SERVICE No. 1020 BULLETIN

DATE: July 10, 1998 (S/M)

**Inspection of the ARTEX 110-4 ELT and
 ELT Attachment Bracket**

**ELT Battery Pack with Data Tag
(Identifies Unit and shows Expiration Date)
If Beyond Expiration Date REPLACE UNIT**

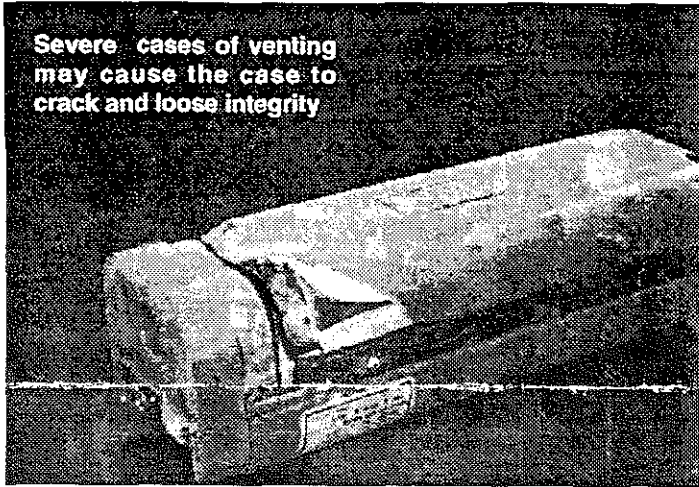
4. If the ELT battery pack is not defective, return it to service for use until the expiration date listed on the data tag. *See the data tag photograph on page 3.*

**ELT Battery Pack
(Severe Damage from Battery Venting)
REPLACE UNIT**

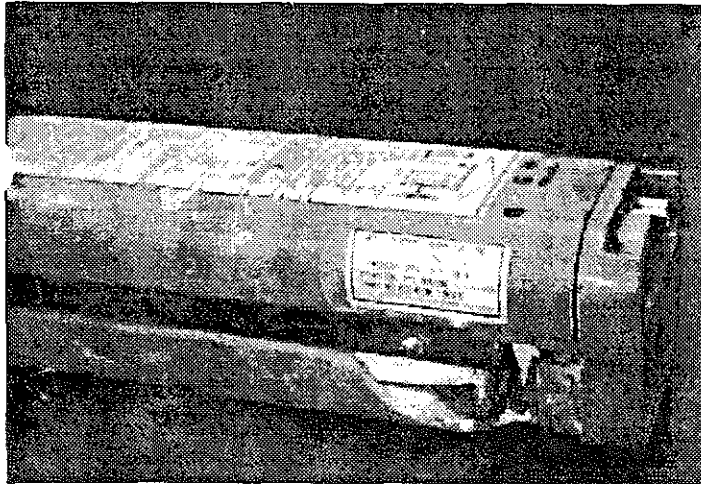
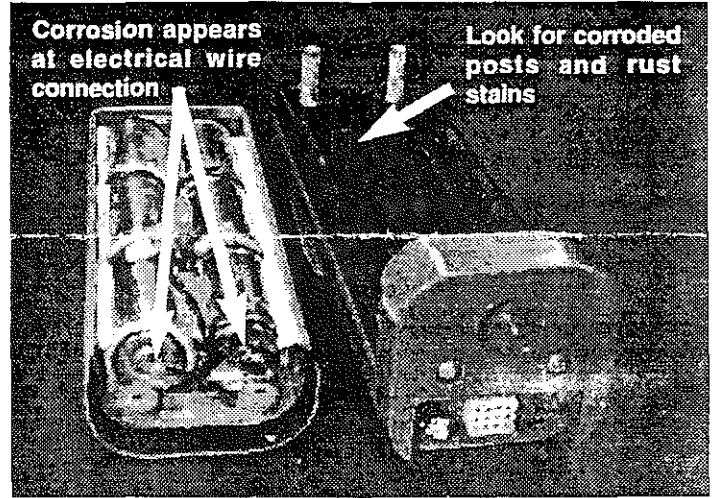
3. If the ELT battery pack does not pass the criteria as set forth in the ARTEX publication, the ELT battery pack must be replaced with a new ELT Battery Pack, Piper Part Number 758-696. *(See the data tag and corrosion photographs on page 3.)*
